**RIDGECREST SOLAR POWER PROJECT (09-AFC-9)  
CEC STAFF DATA REQUEST NUMBERS 79 -118**

**Technical Area: Cultural Resources (AFC Section 5.4)**

**Response Date: January 25, 2010**

**DR-CR-116 Project Area of Potential Effects**

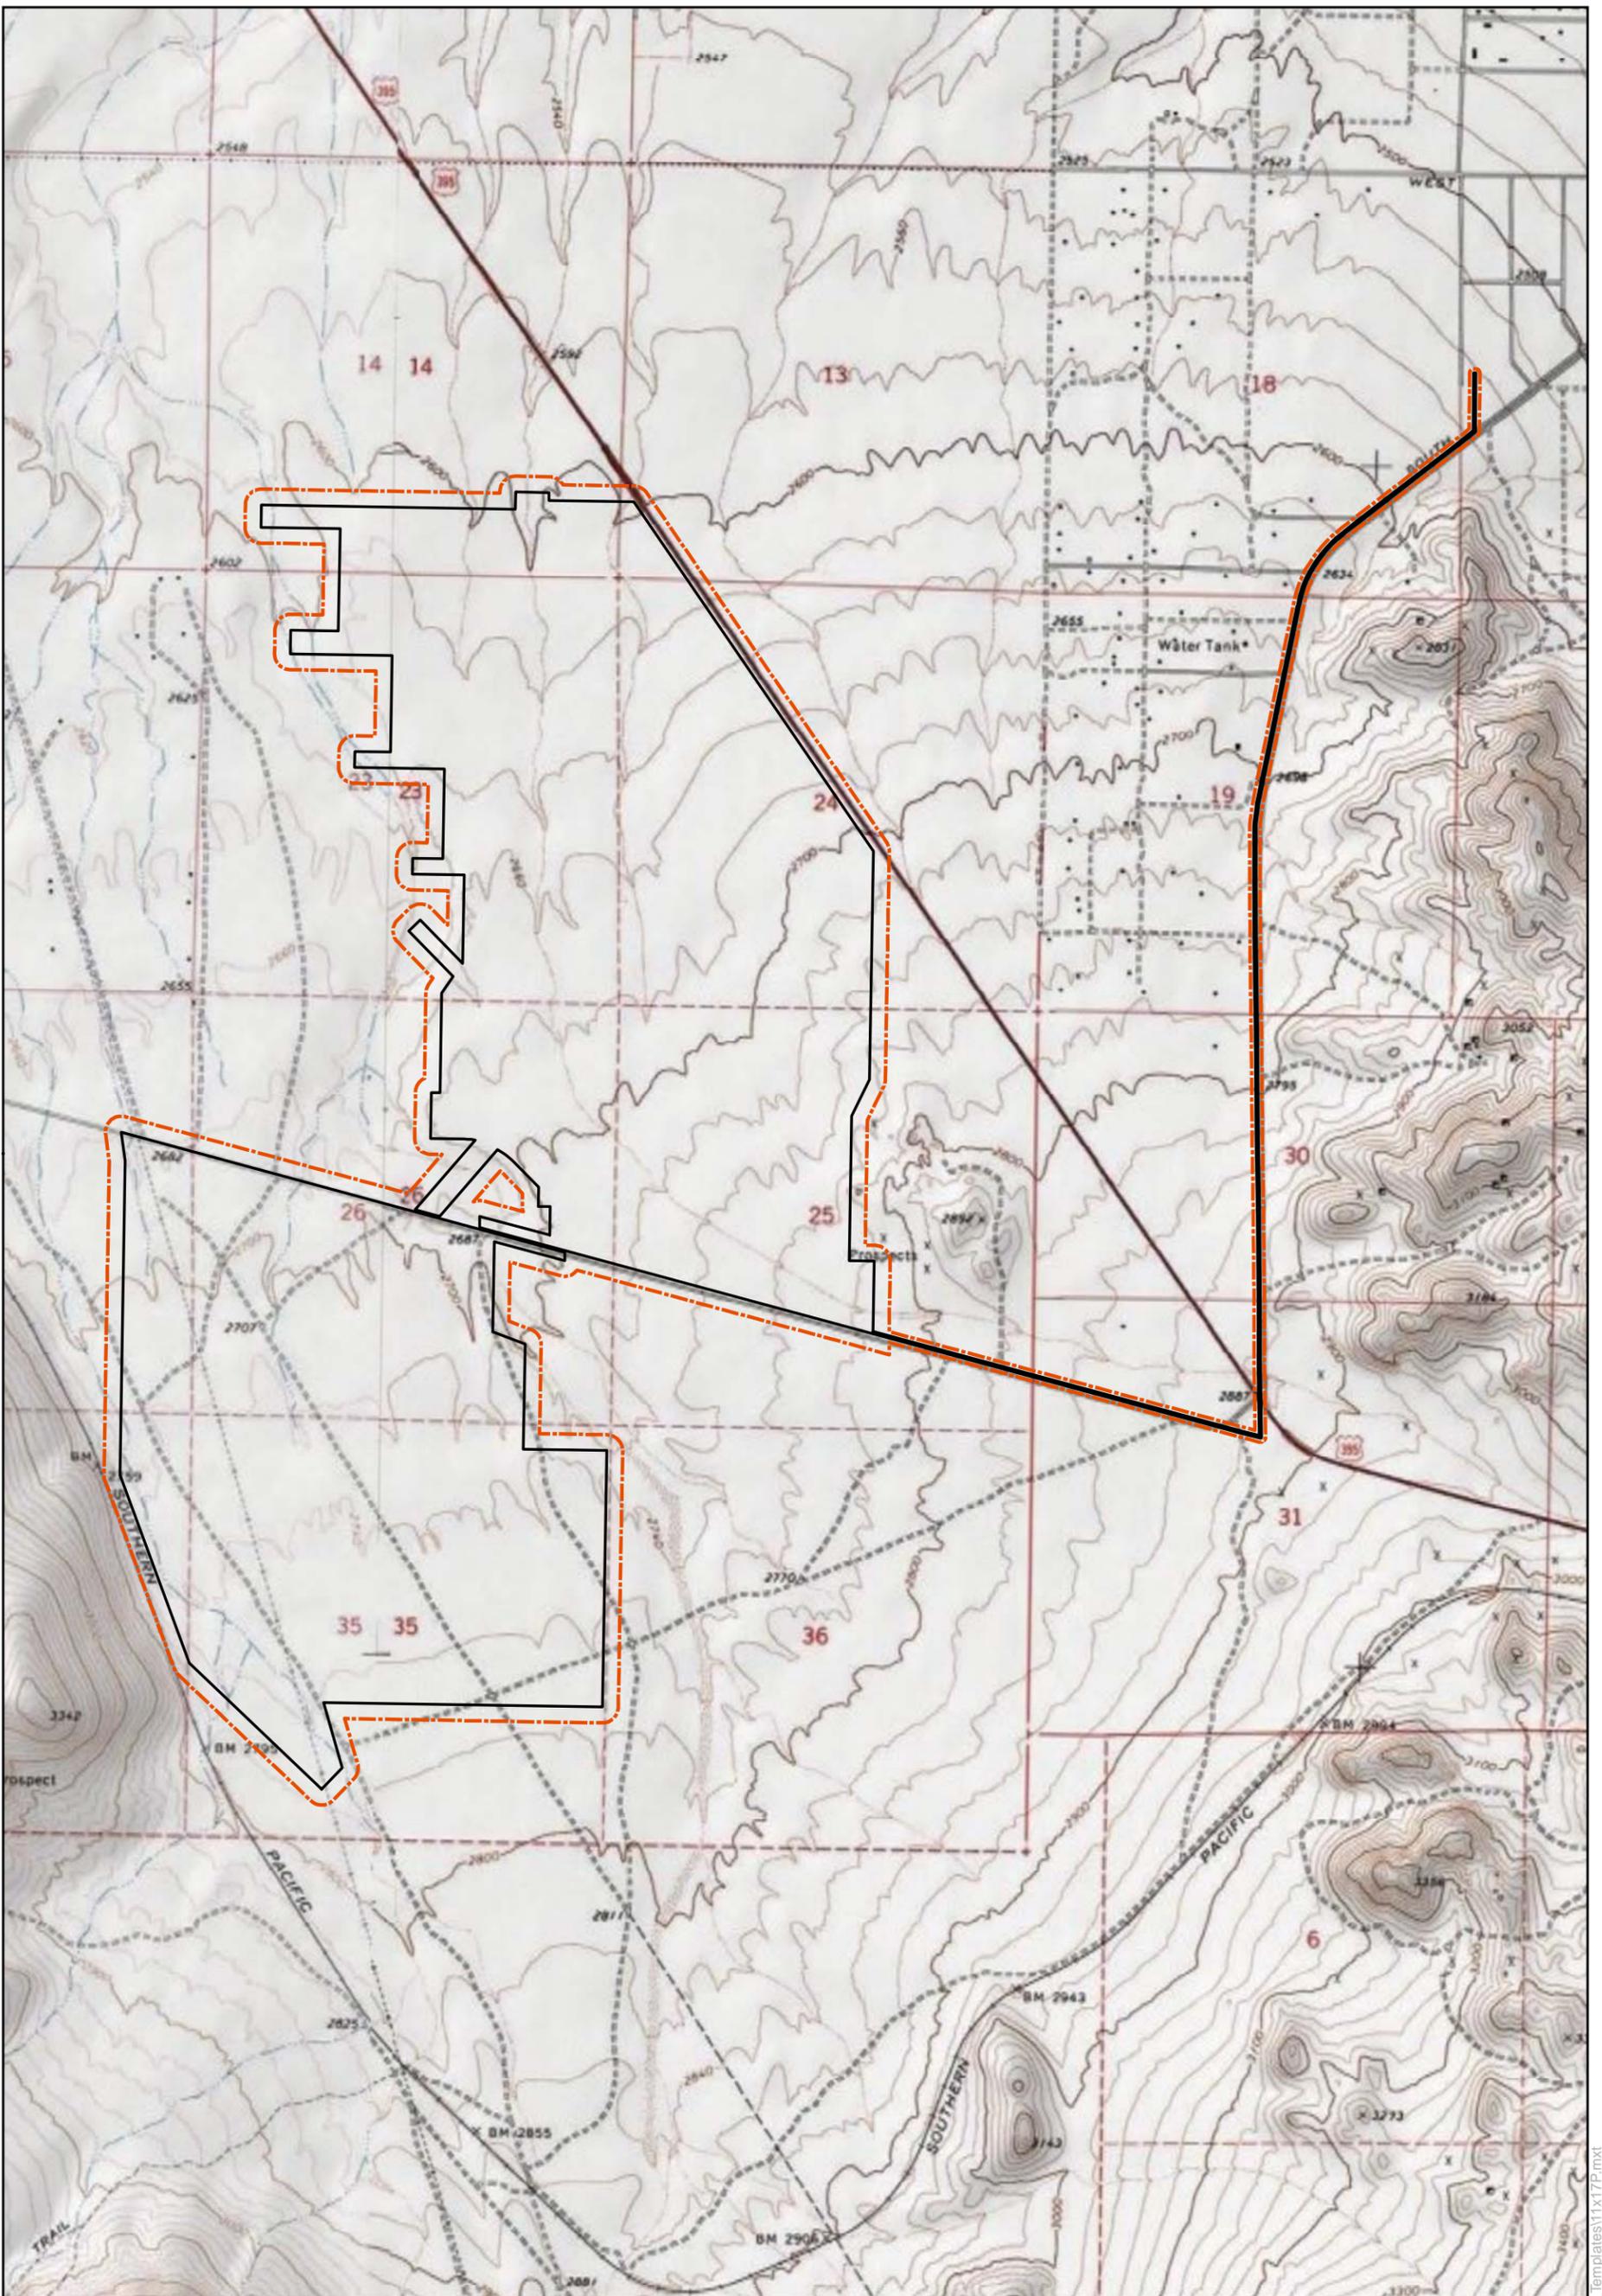
Please provide a map at a scale of 1:24,000 depicting the final and definitive archaeological surface APE for the proposed project.

Please see attached non-confidential map, Figure DR CUL-116.
